AUTOMATIC NOISE LIMITER BOARD (ANL)

ASTRO-200

MODIFICATION

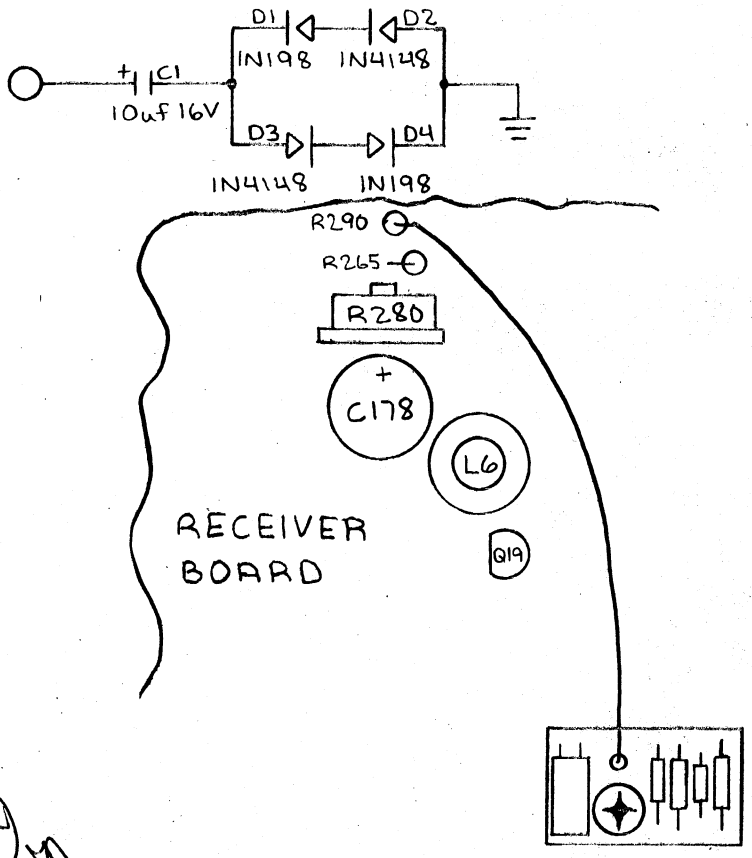
To further improve receiver performance in the presence of spike type noise an ANL circuit board has been added to the Astro 200 receiver. This board limits all spike amplitudes to only 6dB greater than peak audio levels as held by AGC circuits. This circuit is always connected, and reduces false AGC generated by spikes by approximately 2 S-units.
